SUBJECT: ST. LUCIE UNITS 1 AND 2 - ISSUANCE OF AMENDMENTS RE: STANDARDS  
FOR PROTECTION AGAINST RADIATION (TAC NOS. M87159 AND M87160)

The Commission has issued the enclosed Amendment Nos. 125 and 63 to Facility Operating License Nos. DPR-67 and NPF-16 for the St. Lucie Plant, Unit Nos. 1 and 2. These amendments consist of changes to the Technical Specifications in response to your application dated July 23, 1993.

AMENDMENT NO. 125 TO FACILITY OPERATING LICENSE NO. DPR-67 - ST. LUCIE, UNIT 1  
AMENDMENT NO. 63 TO FACILITY OPERATING LICENSE NO. NPF-16 - ST. LUCIE, UNIT 2

2. Figure 5.1-1 SITE AREA MAP

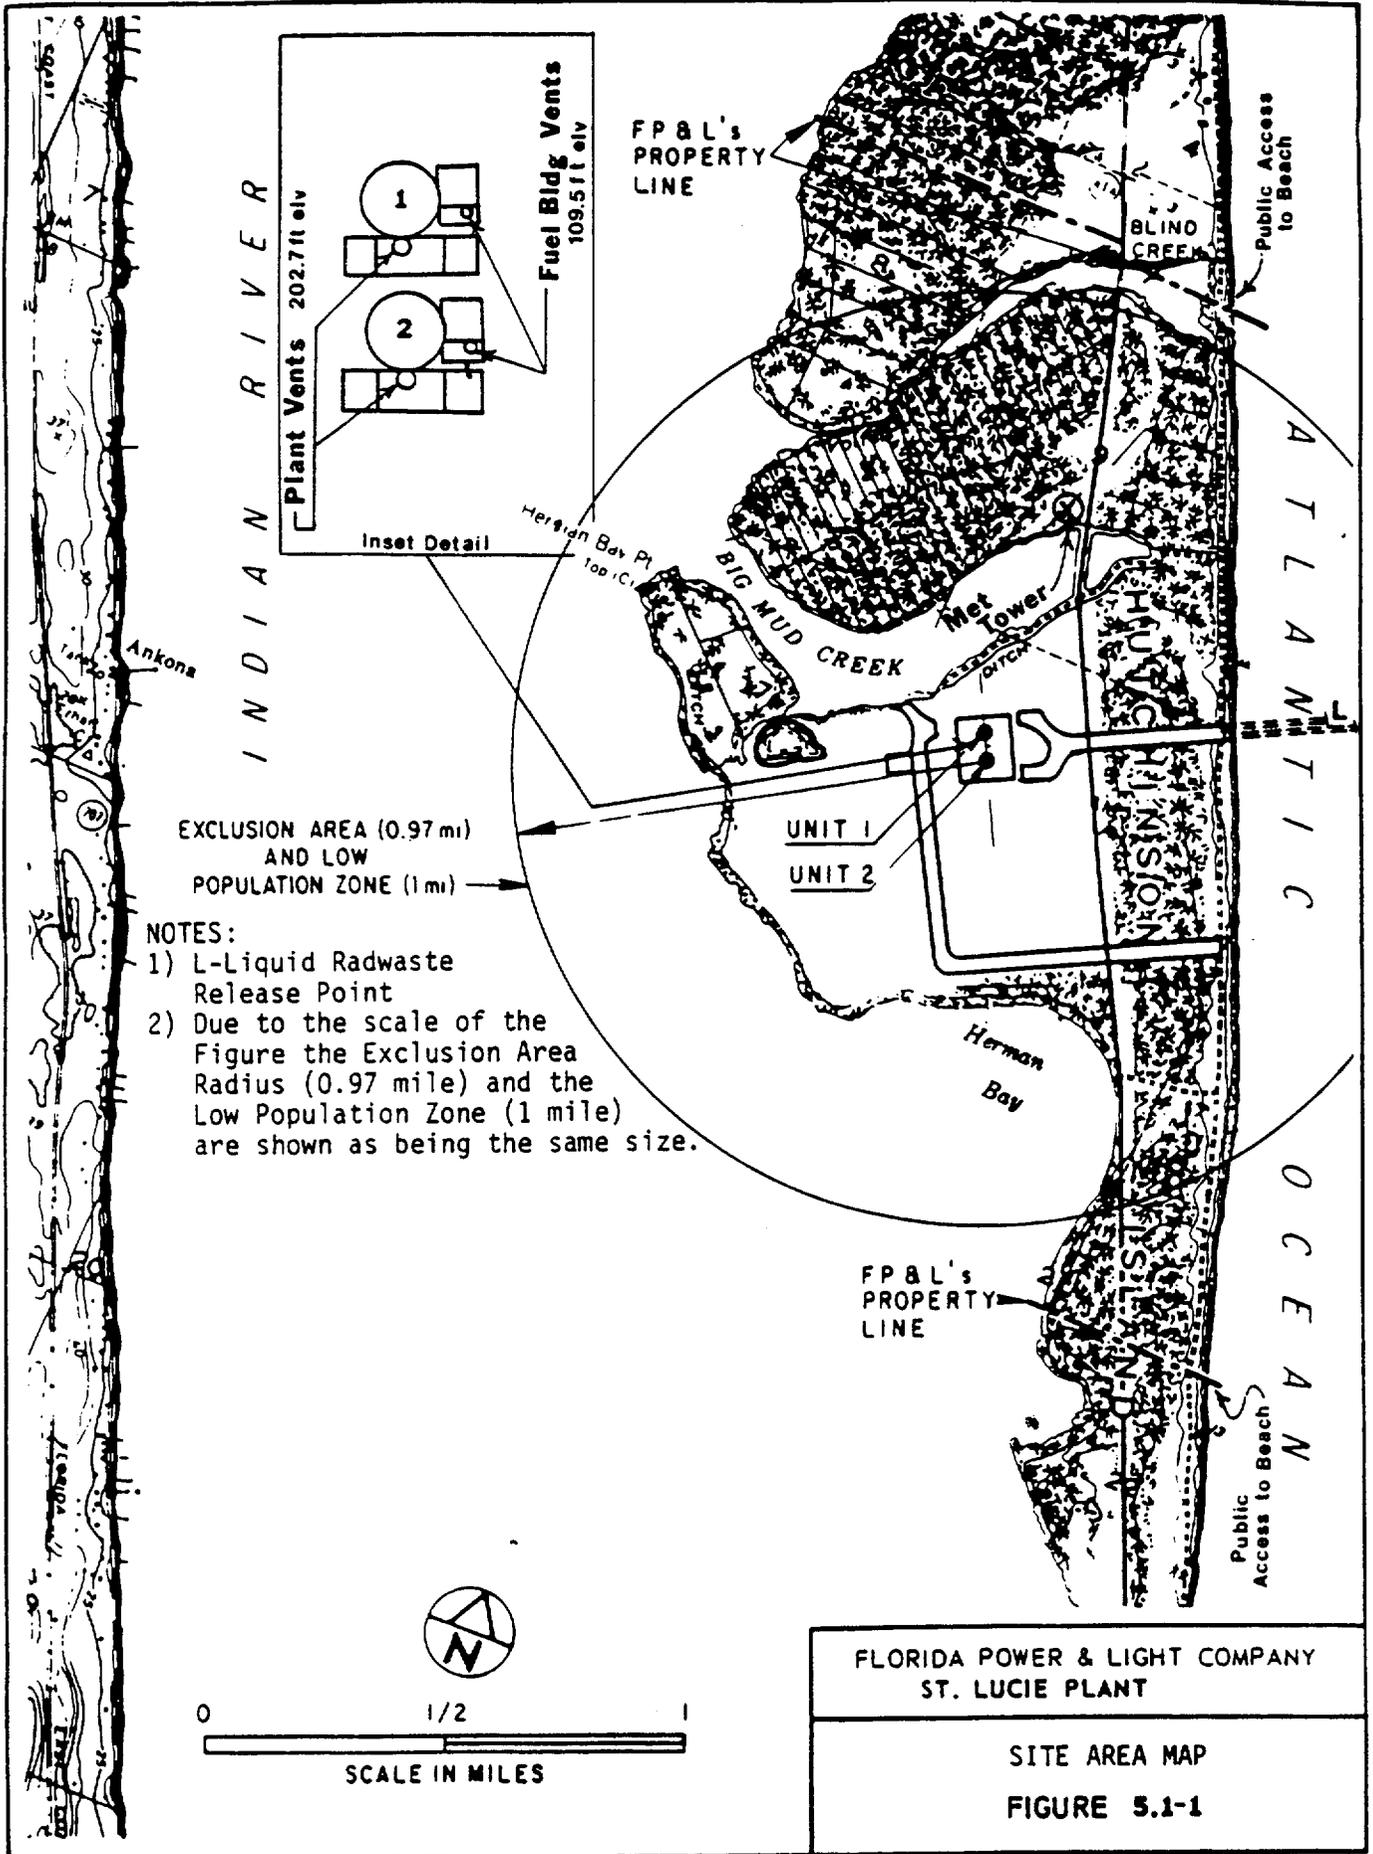
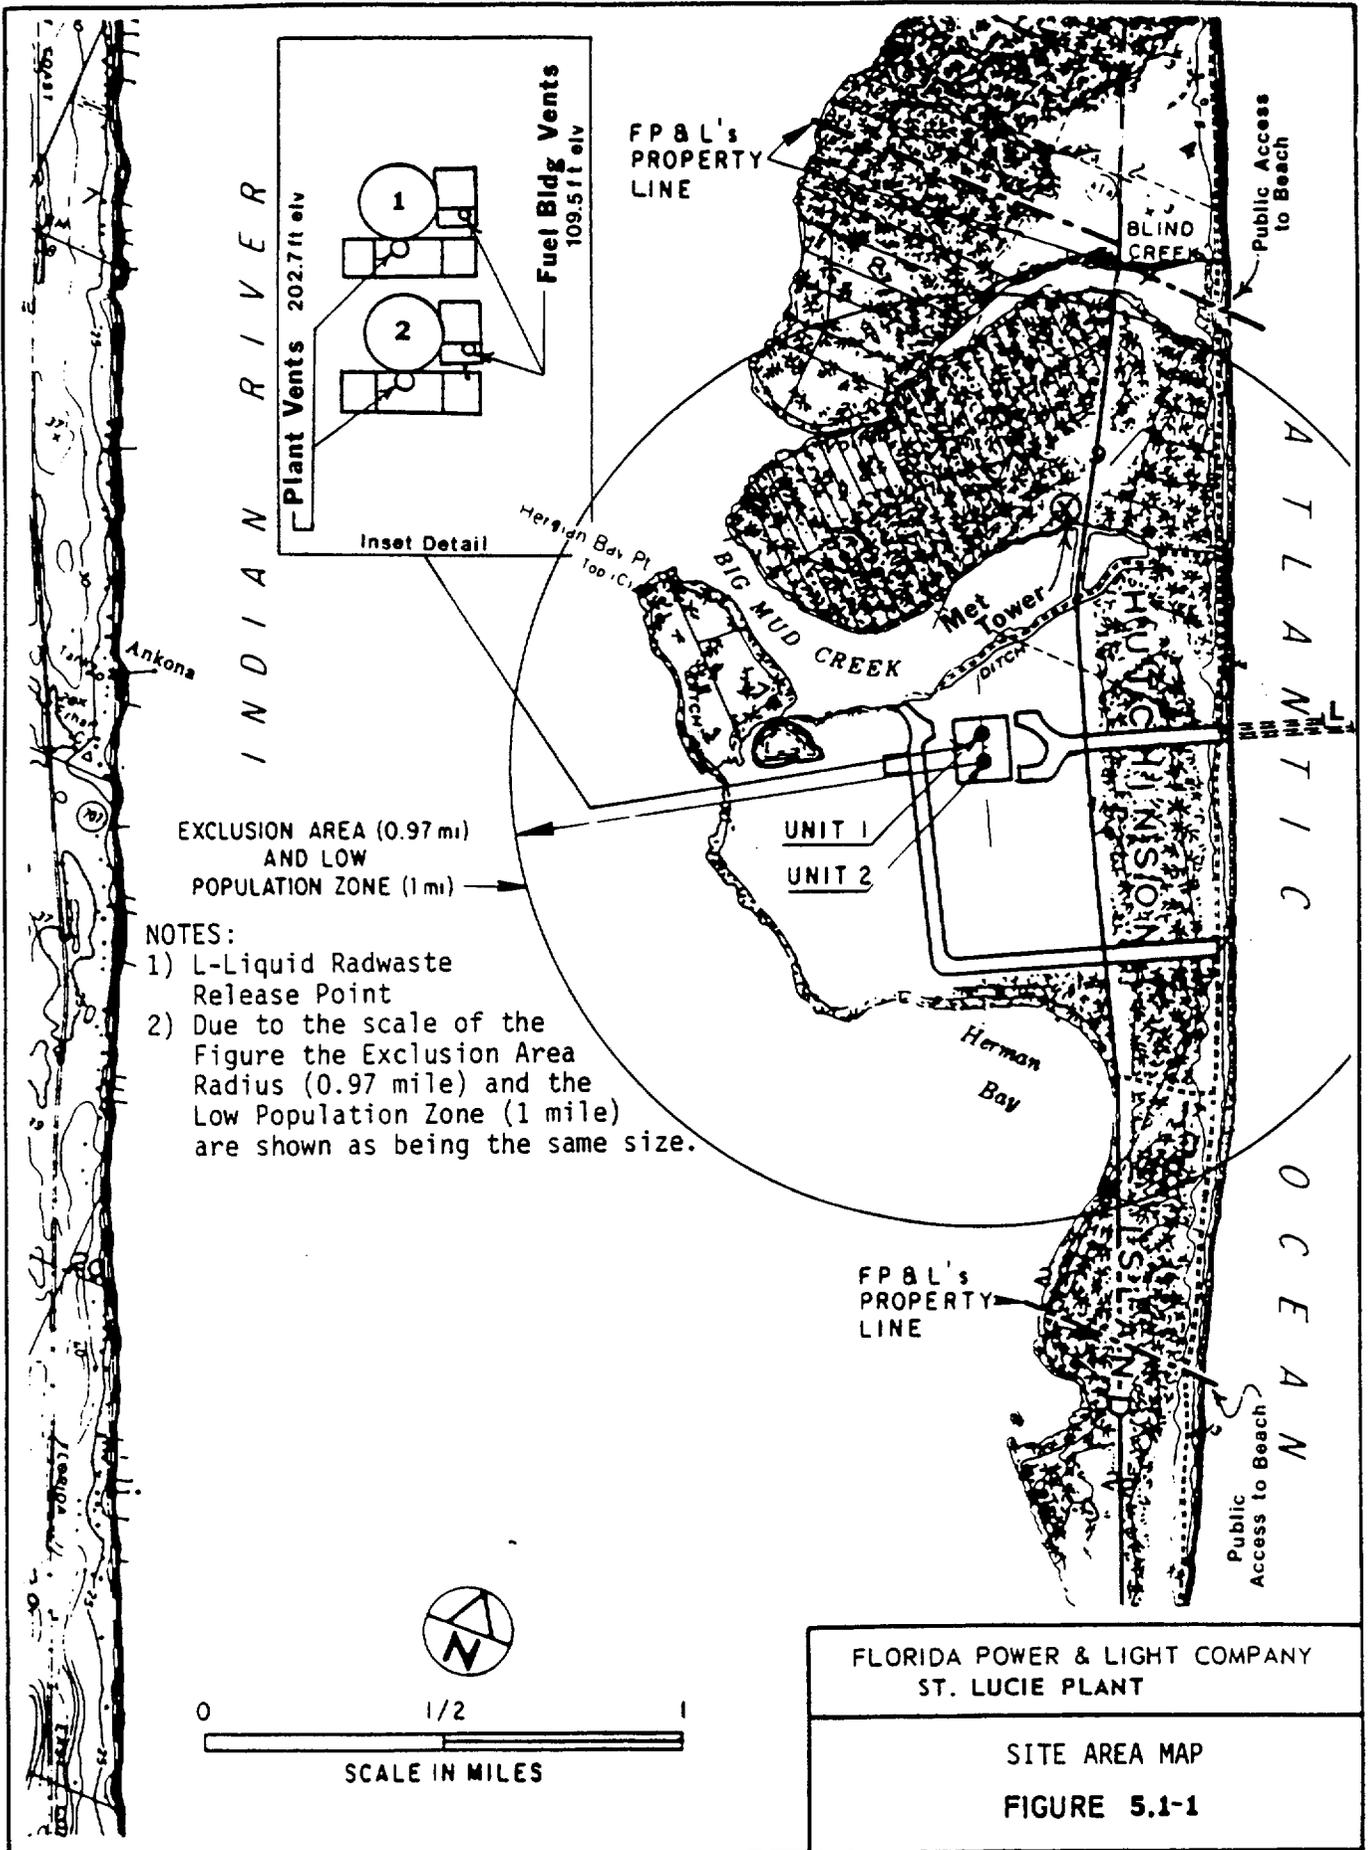
The licensee has proposed to delete Note 3), which lists areas that are considered UNRESTRICTED AREAS. The licensee now considers the areas to be controlled areas as defined in 10 CFR 20.1003. Therefore, the note is unnecessary since all areas within the licensee's property line are controlled.

The change is administrative in nature and is acceptable.
